STAFF RECOMMENDATION
1217 5th Avenue North
Date of Public Hearing

Application: New Construction – Rear addition
District: Germantown Historic Preservation Zoning Overlay
Council District: 19
Map and Parcel Number: 08209028700
Applicant: Berdelle T. Campbell, Owner
Project Lead: Sean Alexander, sean.alexander@nashville.gov

| <p>Description of Project: The applicant is proposing to construct a one-story addition at the rear of the house, attached to the rear of an earlier “sunroom” addition. The materials of the new addition will match the earlier addition. A reduction of the side setback from three feet (3’) to one foot (1’) is also requested.</p> <p>Recommendation Summary: Staff recommends approval of the proposed addition and setback reduction, finding it to be compatible with the historic context and to meet the Germantown Historic Preservation Zoning Overlay design guidelines.</p> | <p>Attachments A: Photographs B: Site Plan C: Elevations</p> |

PROPOSED
ADDITION

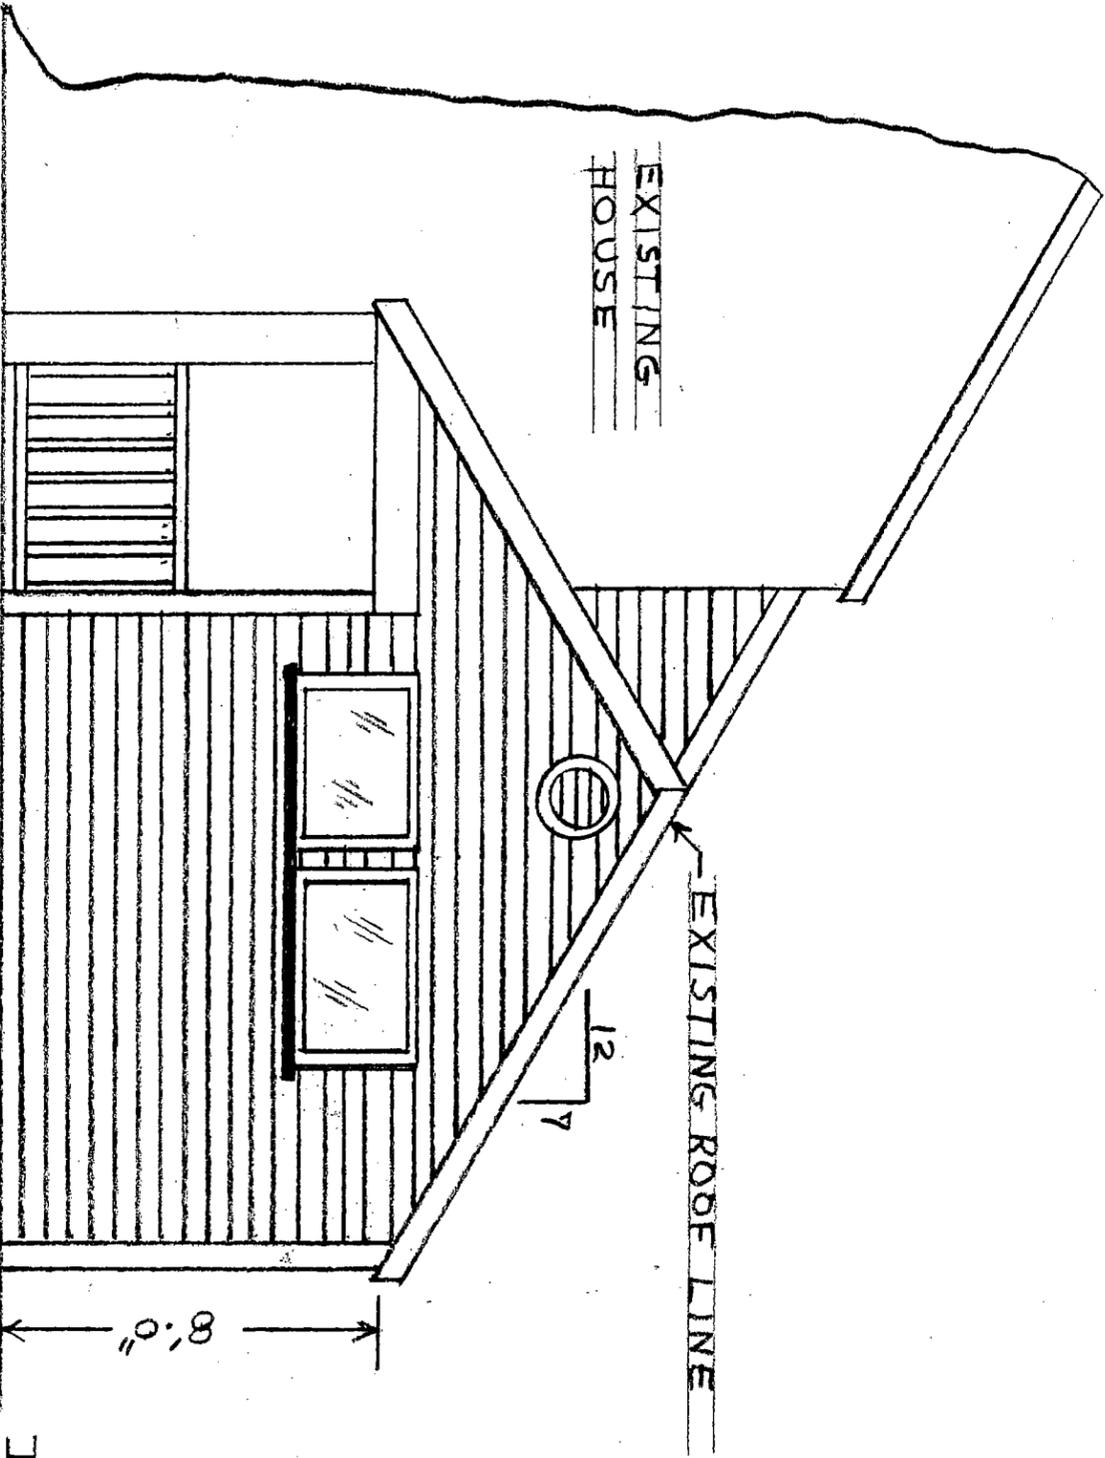
The new addition will have a four hundred, fifty square foot (450 sq. ft.) in footprint, stepping out to the left of the outside edge of the earlier addition by four feet, six inches (4’-6”). This location will not negatively impact the appearance of the original structure because it will be attached to an earlier “sunroom” addition, which extends more than twenty-five feet (25’) behind the rear wall of the original structure.

Under the current Zoning regulations, single family dwelling on this lot is required to meet a three foot (3’) side setback, although historically structures in Germantown were built with little or no setback buffers. The proposed addition would sit one foot from the

left property boundary. Because the reduced setback would be in keeping with the historic pattern of development in the neighborhood, staff finds it to be appropriate and to meet guideline 22.1.

Staff recommends approval of the proposed addition and setback reduction, finding it to be compatible with the historic context and to meet the Germantown Historic Preservation Zoning Overlay design guidelines.

REAR VIEW
SCALE 1/4" = 1'

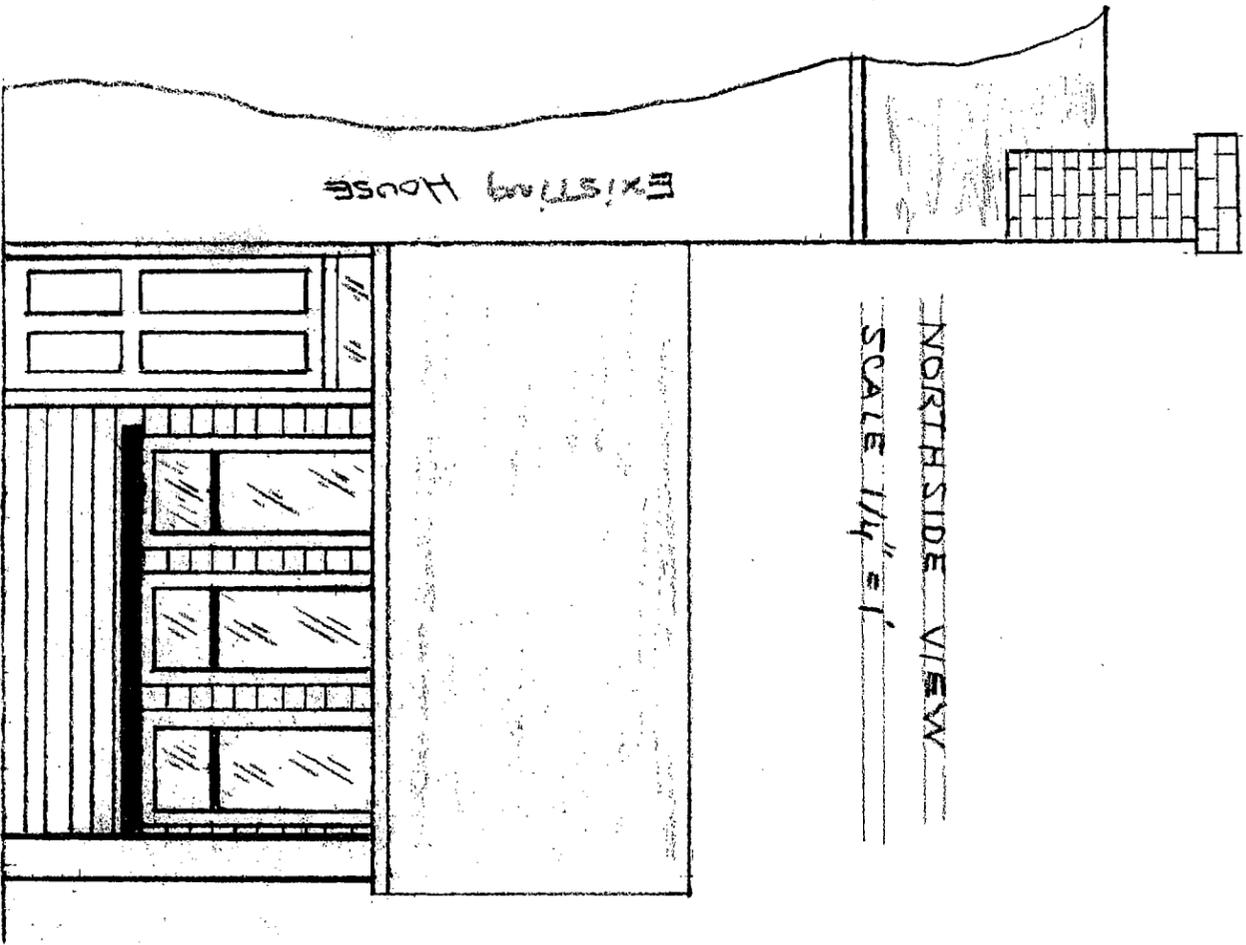
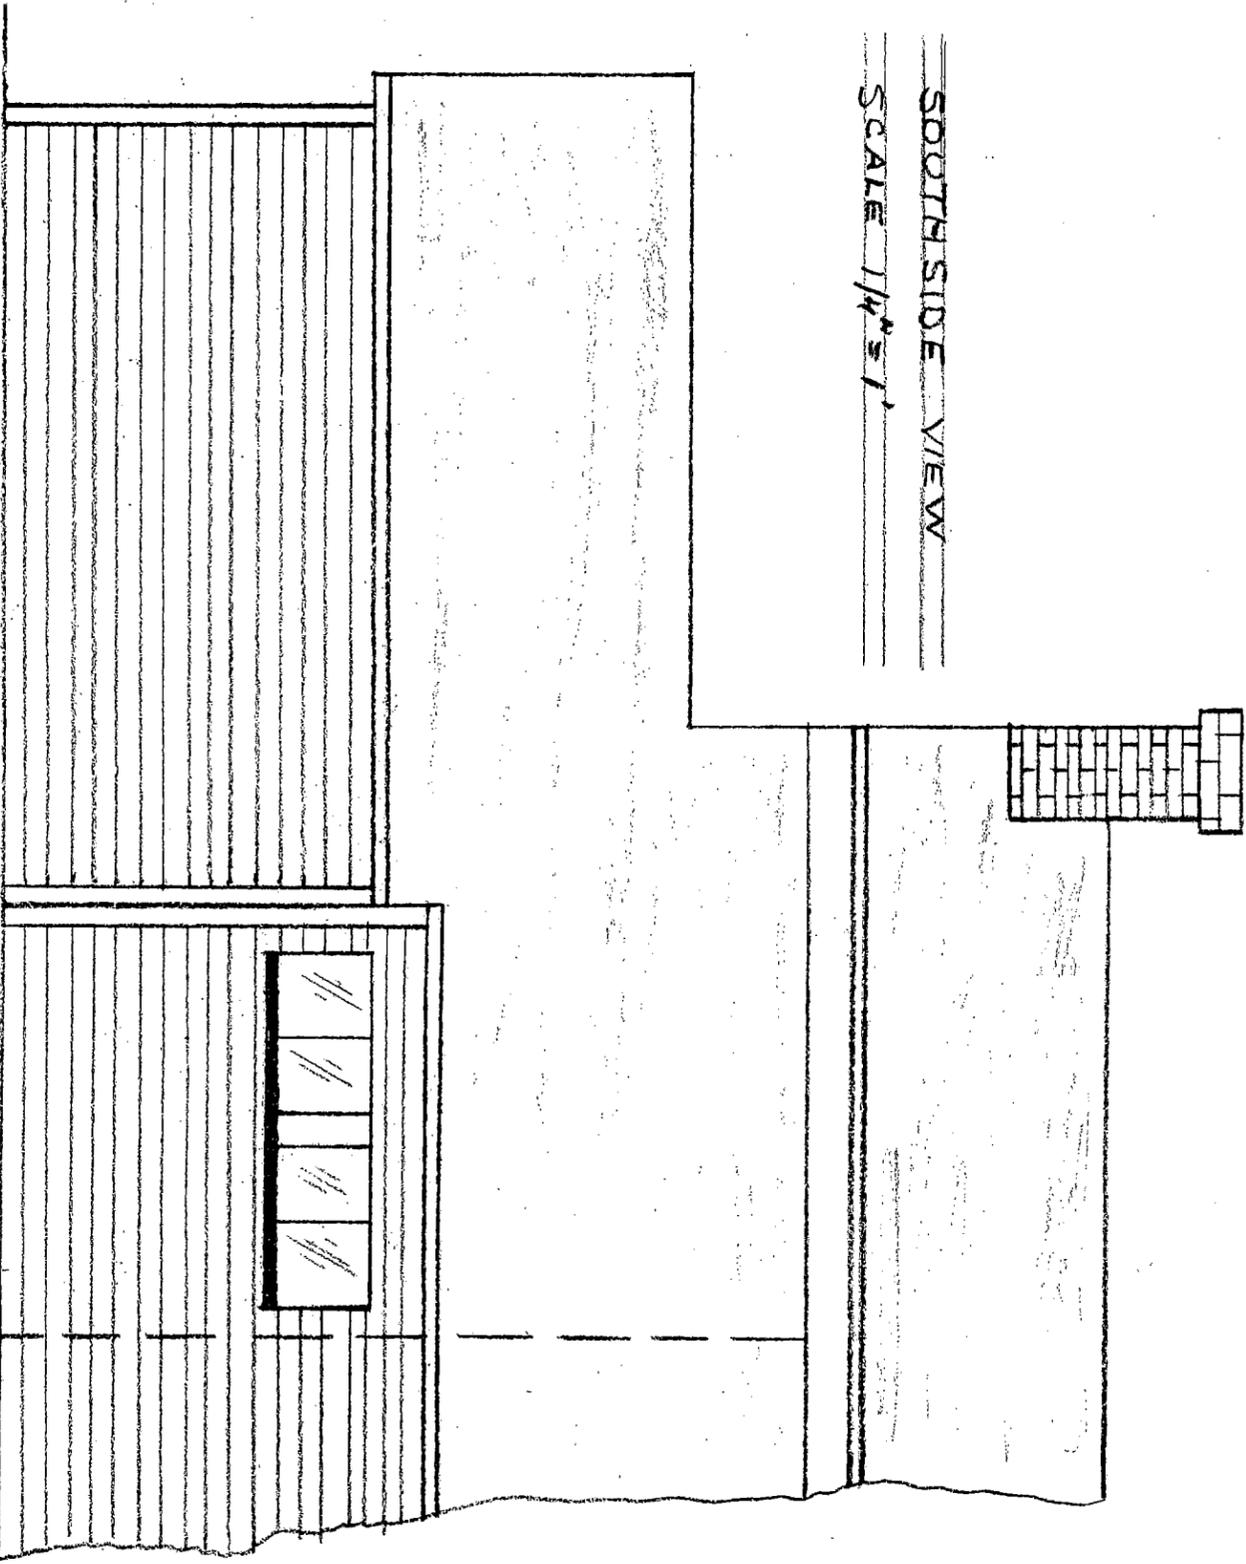
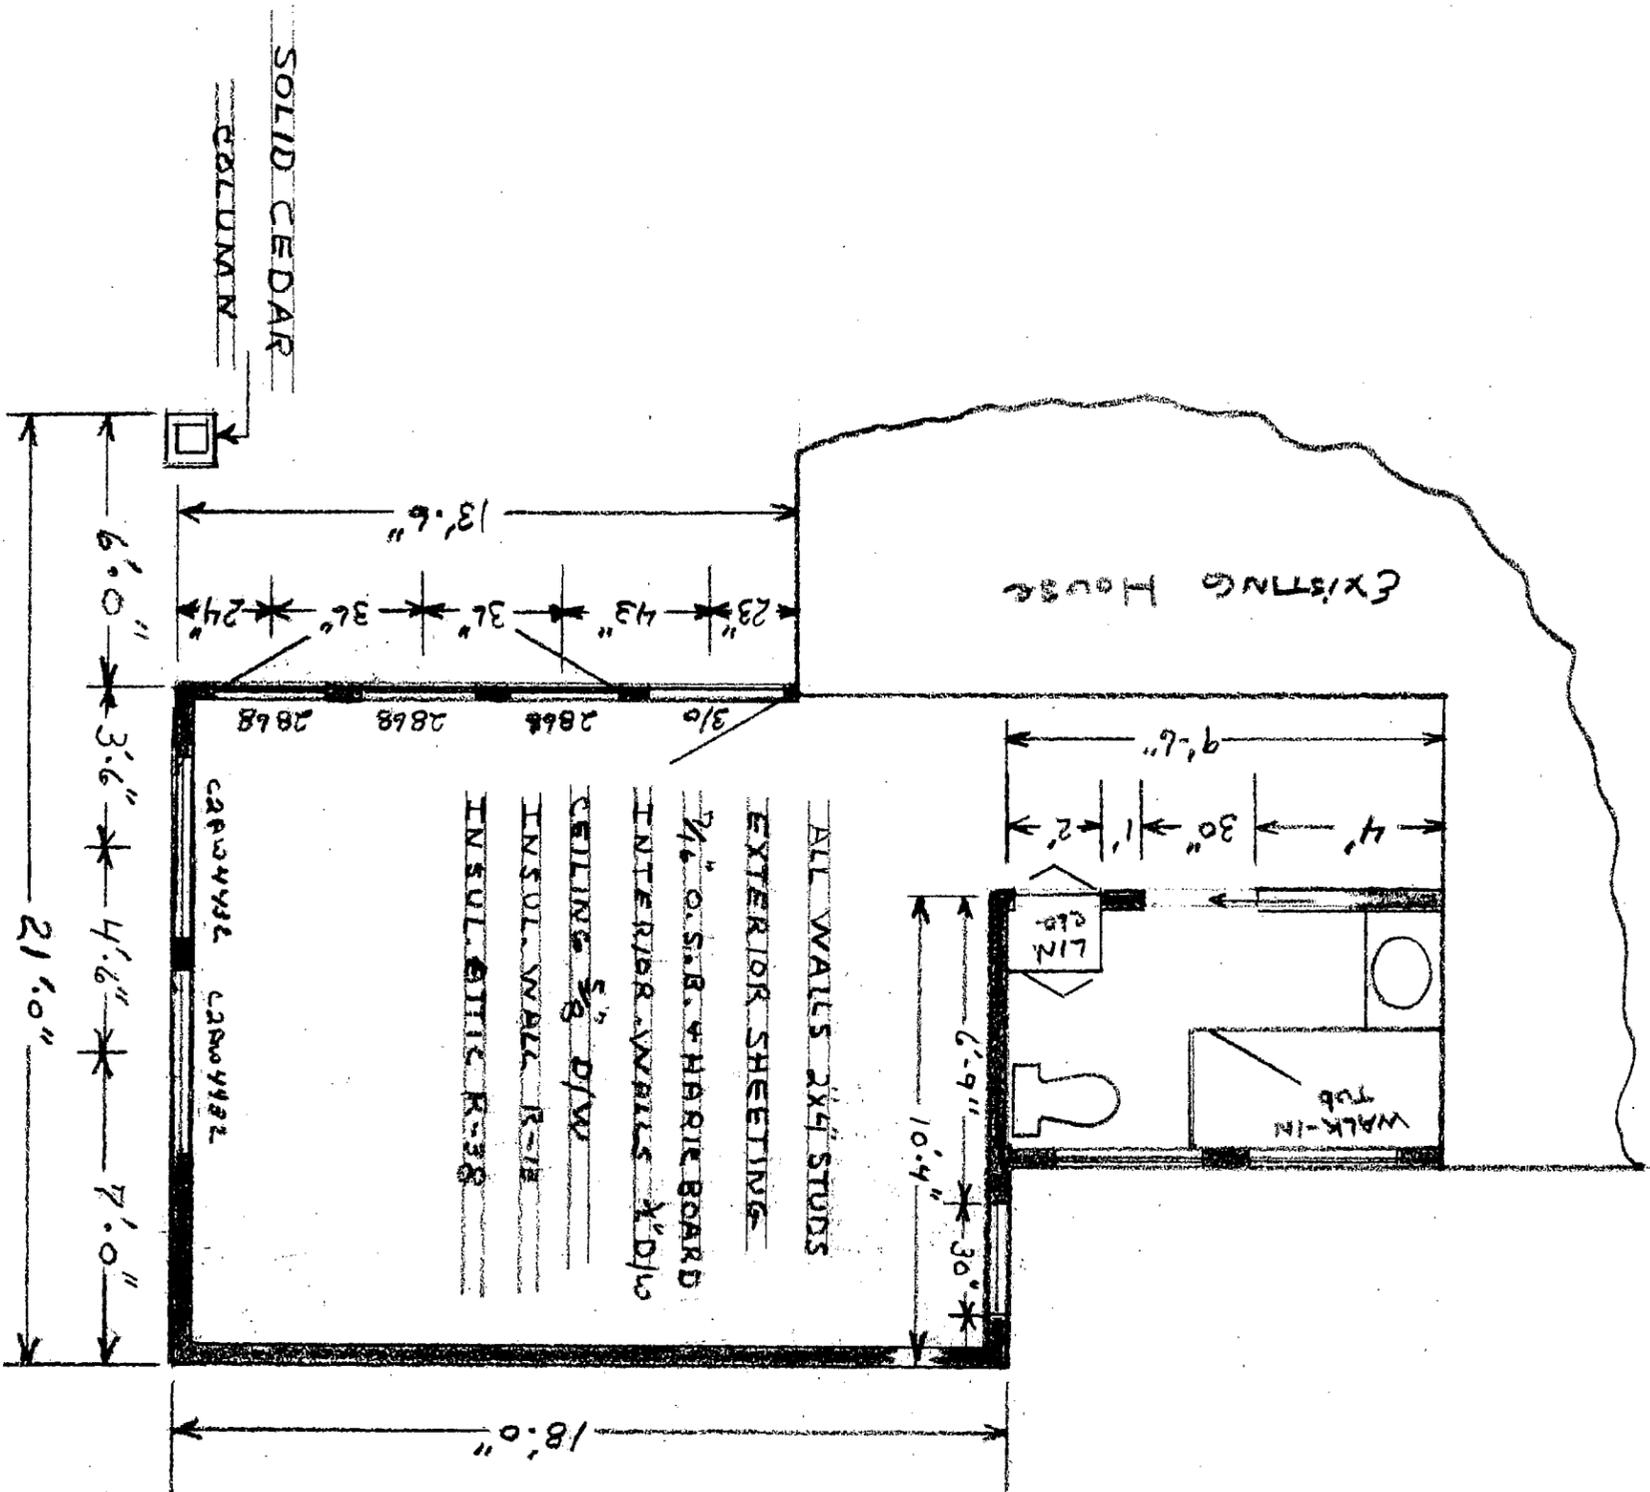
The roof of the new addition will be a shed-roof, matching the pitch of the earlier addition, but meeting the side wall one foot (1’) below the eave. The eave line will terminate eight feet (8’) above grade. Staff finds the height and massing of the addition to be subordinate to and compatible with the historic house, and to meet guidelines 2.2.3 and 2.2.4, and the roof to meet guideline 2.2.7.

The exterior of the addition will be clad with wood and trim, with a fiberglass-asphalt shingle roof to match the materials of the earlier addition. In the small front-facing wall of the addition will be a wooden double-hung window. These materials are compatible with the historic house and meet guideline 2.2.4 and 2.2.6.
